2-9169A

SERVICE MANUAL

216C8817

TITLE
SCHEMATIC
FIRST MADE FOR 2-9189A

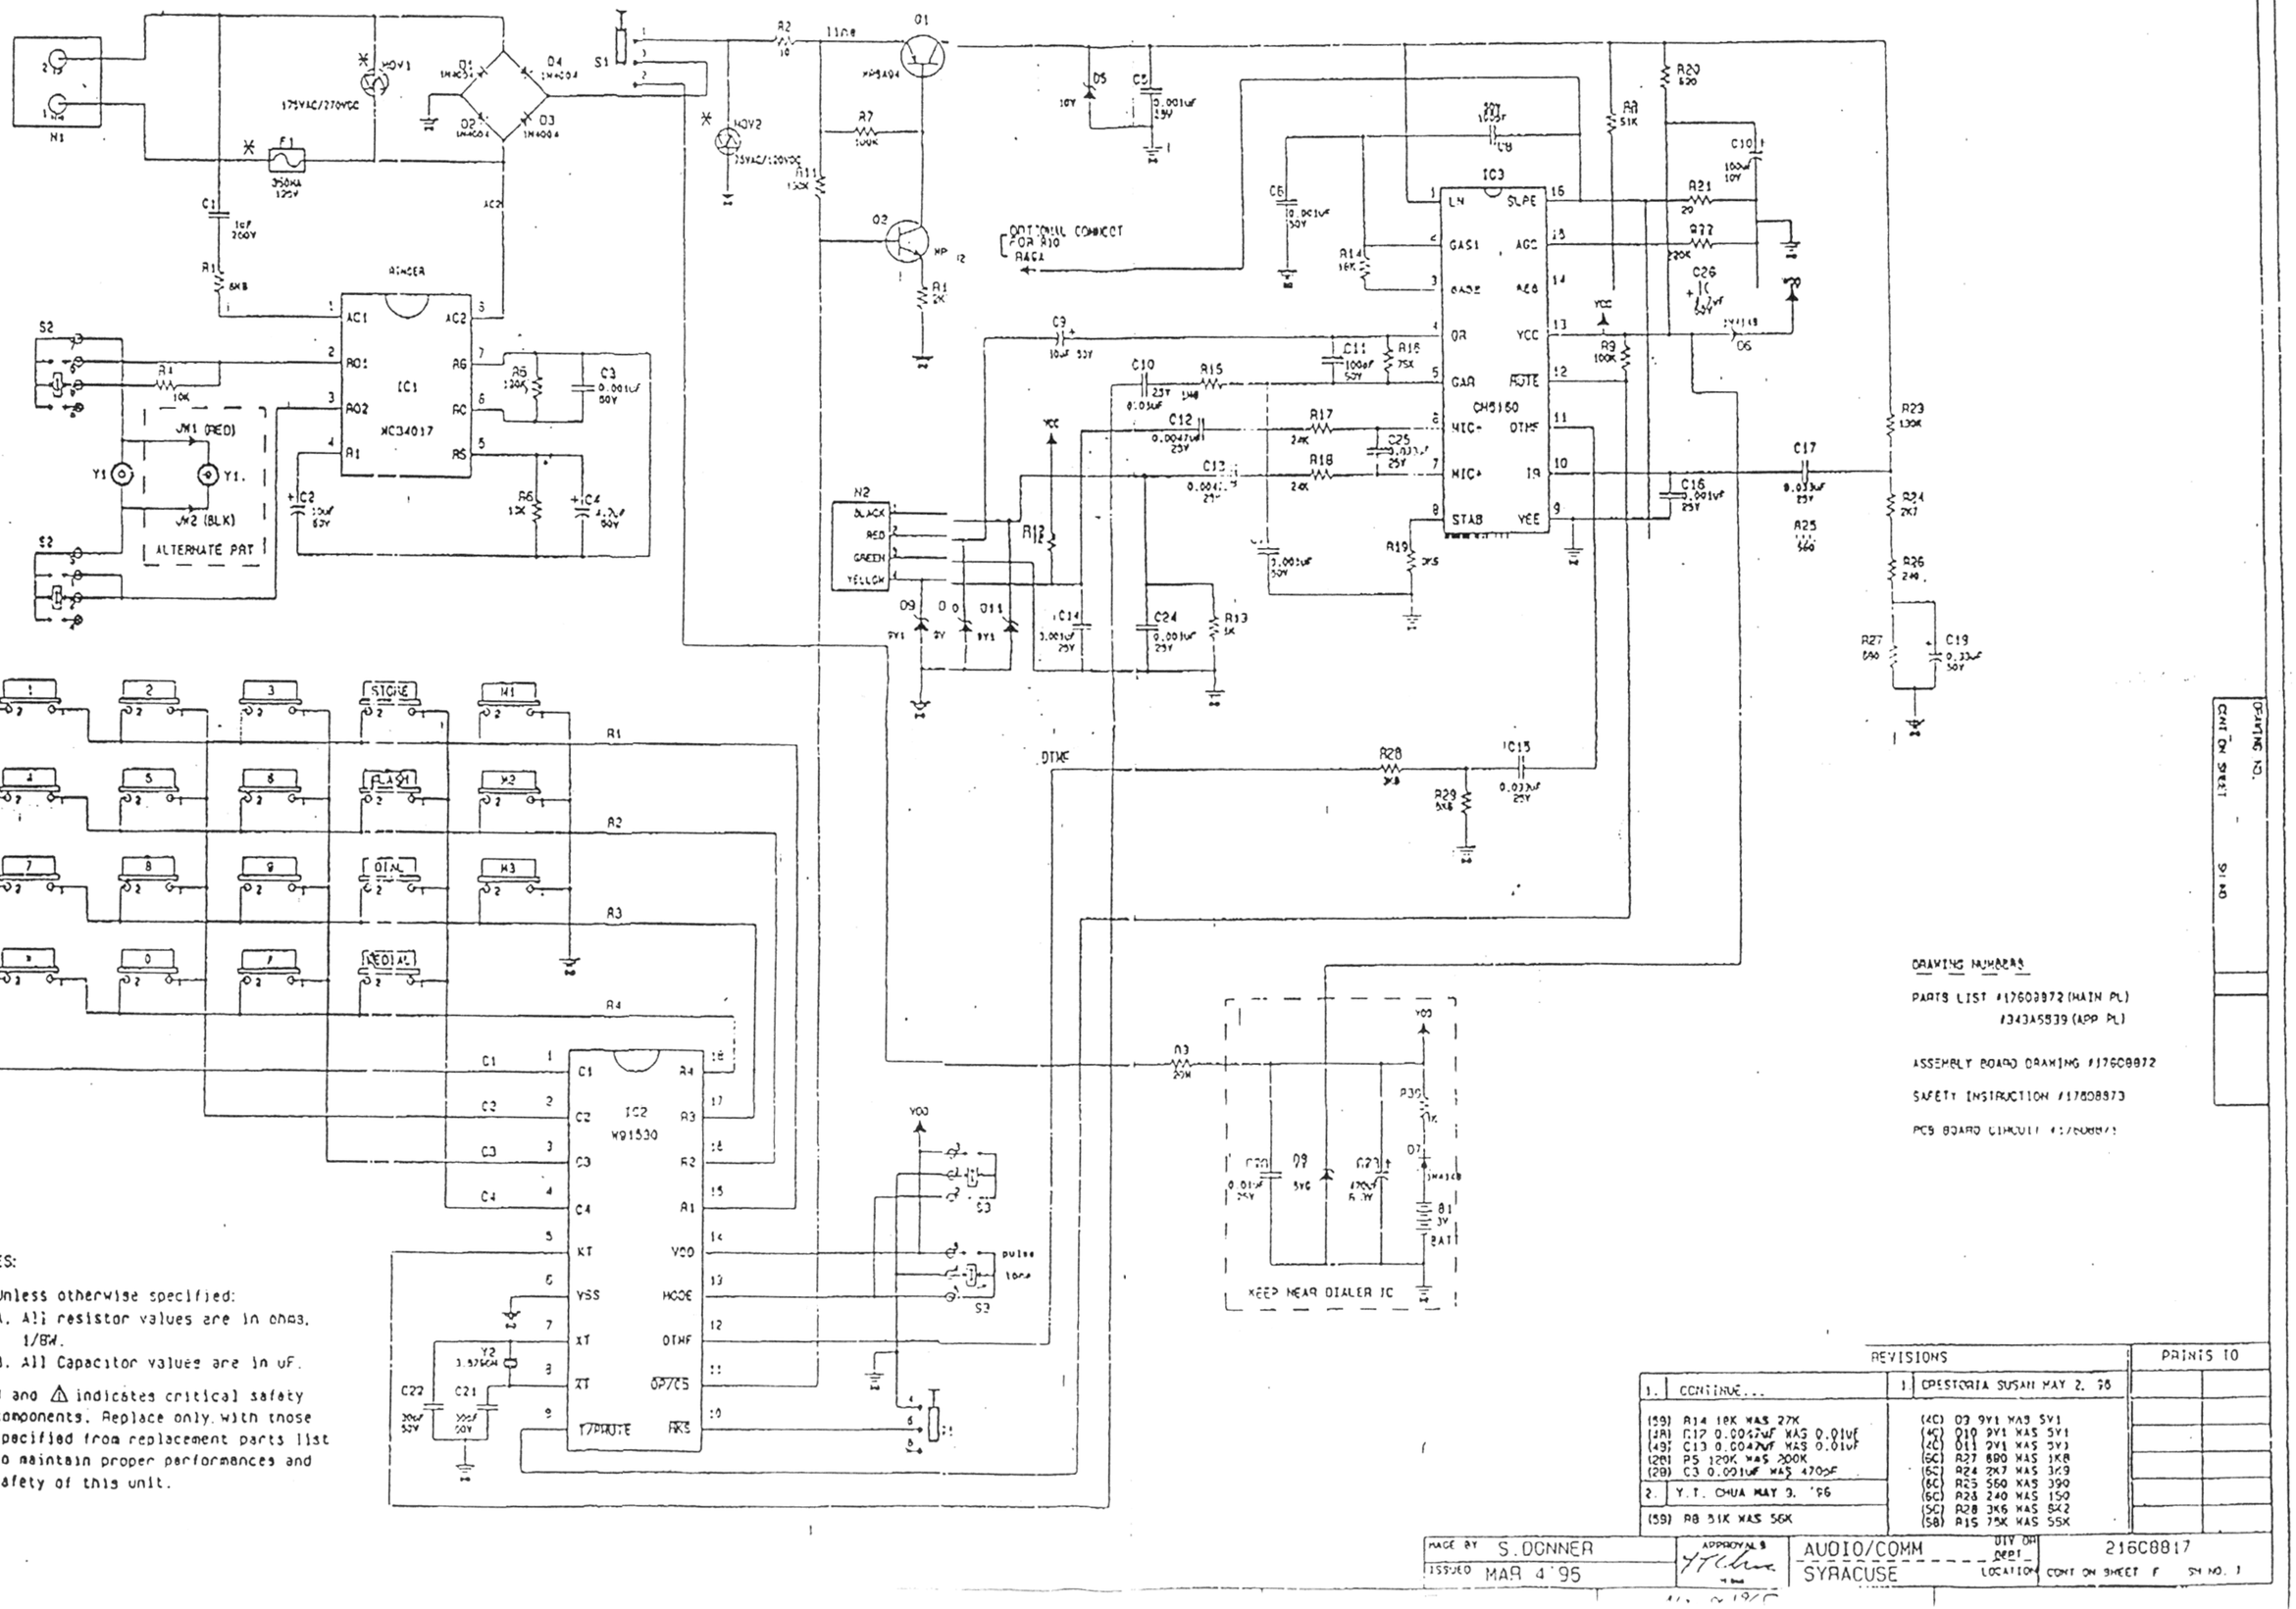
REVISIONS		PRINTS TO
1. CONTINUE...	1. CRESTORIA SUSAN MAY 2, 96	
(5B) R14 18K WAS 27K (3A) C17 0.0047uF WAS 0.01uF (4B) C13 0.0047uF WAS 0.01uF (2B) R5 129K WAS 200K (2B) C3 0.001uF WAS 4700pF	(4C) D3 9V1 WAS 5V1 (4C) D10 9V1 WAS 5V1 (4C) D11 9V1 WAS 5V1 (6C) R27 680 WAS 1K8 (6C) R24 2K7 WAS 3K9 (6C) R25 560 WAS 390 (6C) R28 240 WAS 150 (5C) R28 3K6 WAS 8K2 (5B) R15 75K WAS 56K	
2. Y.T. CHUA MAY 3, '96		
(5B) R8 51K WAS 56K
